# SAFETY RECALL

Date	Number	Release	Page
07.2024	SC0465	01	1(5)

## Steering Draglink Additional Inspection (2) AN, GR, TE

**Added 121-24 NOK Suspect Build Date to part number 21129355.  
Added 107-24 NOK Suspect Build Date for part number 23685511.**

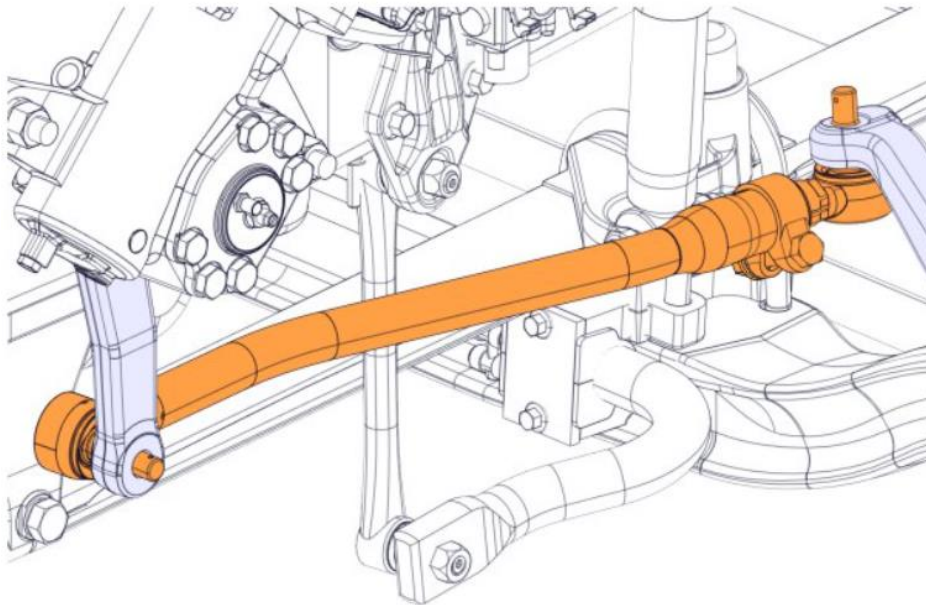
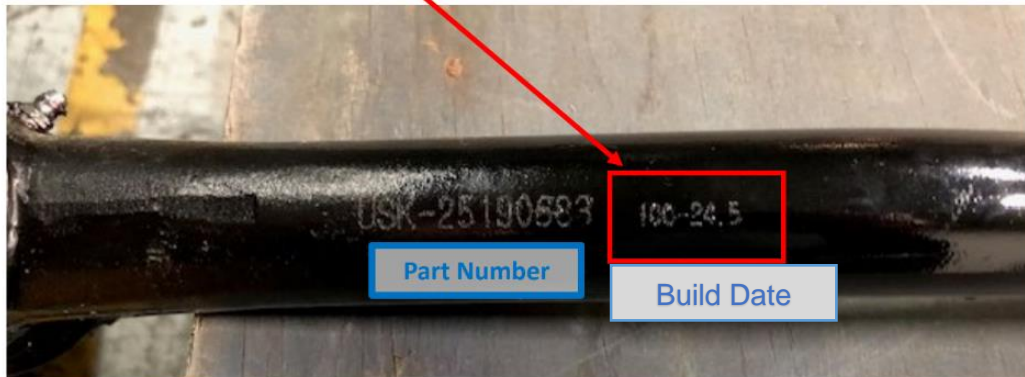
5. Identify the draglink assembly connecting the steering lever and the pitman arm.

**NOTE: Some trucks may have dual draglinks depending on configuration.**

6. Locate the part number stamped or etched on the draglink.

7. Verify the part number on the draglink to the reference part number in the table below. Confirm whether the part number and build date match or not.
  - a. If the build date matches to the dates on the table, the draglink is NOK and must be replaced with a new one. Proceed to step 8.
  - b. If the build date is not on the table, the draglink is OK and the truck can be returned to service.
